BKO Parmer

4801 East Yager Lane

SP-2021-0034D

# OUTLINE

# Grading Exhibit (Cut and Fill)

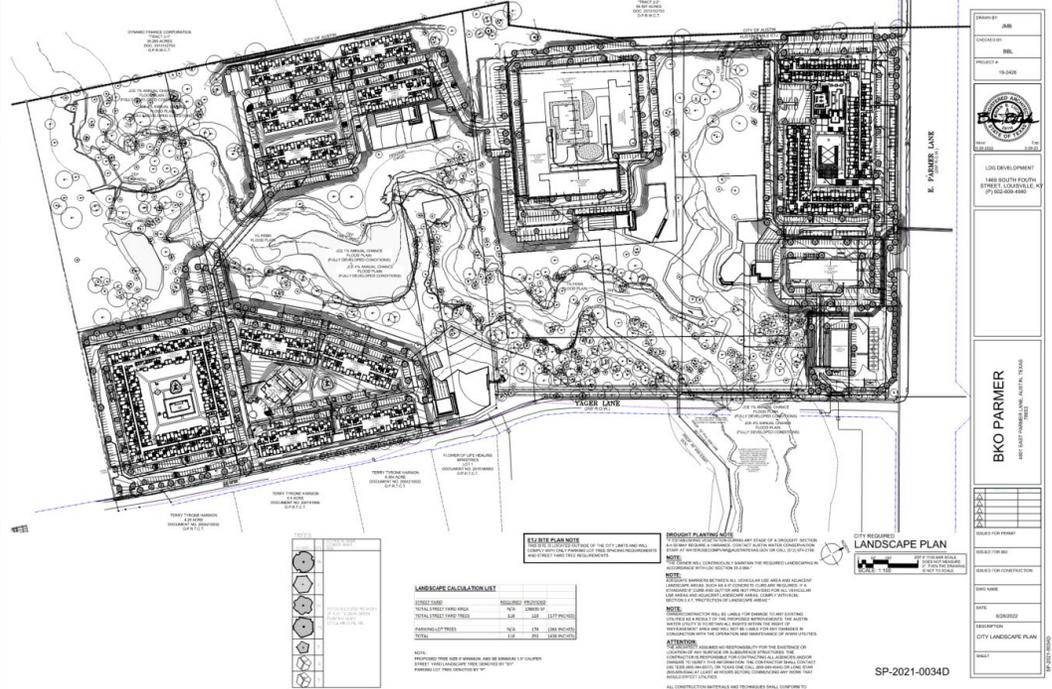
- ▶ To allow fill in excess of 4 feet and up to 12 feet within the Desired Development Zone. (LDC 25-8-342)

MAXIMUM FILL = 12.0 FEET

variance Exhibits

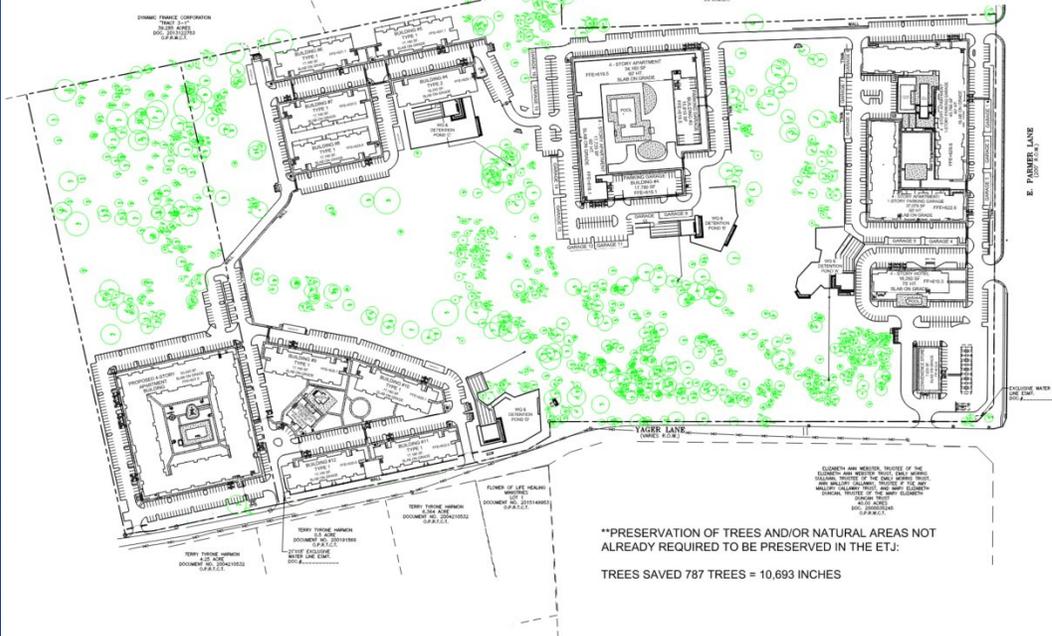
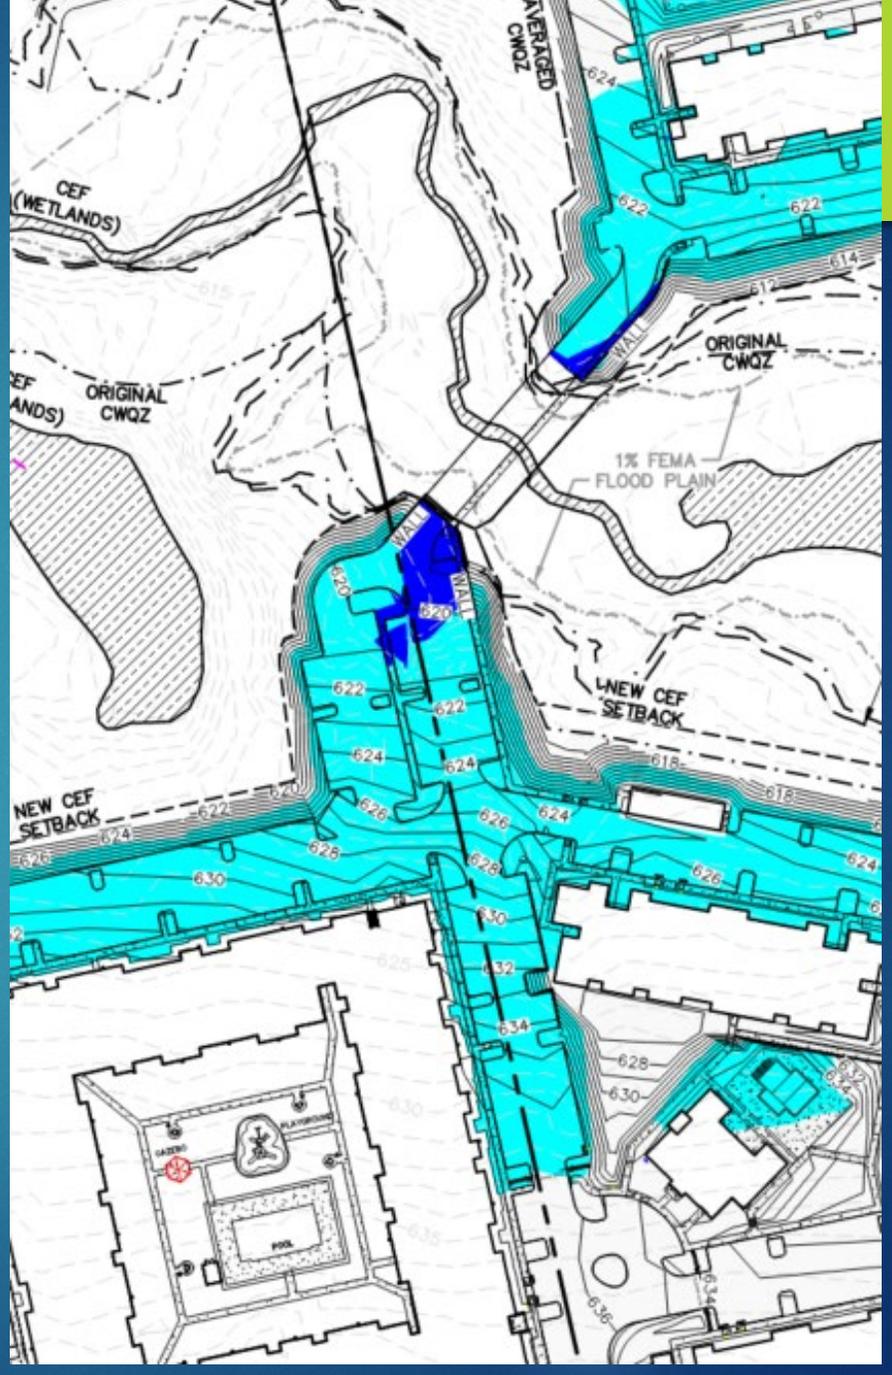
Staff recommends the variance, having determined that the required findings of fact have been met.

Staff also recommends and supports the following conditions in accordance to approved variance exhibits:

1. Preservation of trees and/or natural areas not already required to be preserved in the ETJ:
  - Trees Saved 787 trees = 10,693 inches
2. Apply City of Austin Landscaping Ordinance on this ETJ site:
  - Added 118 Street Yard Trees (118 Trees Required) = (177 inches added)
  - Added 174 Landscape Islands/Medians/Peninsulas Trees = (261 inches added)
  - Total Trees Added = 292 Trees = (438 inches added)
3. Add retaining walls (1,375 lf) to contain the major fill areas.
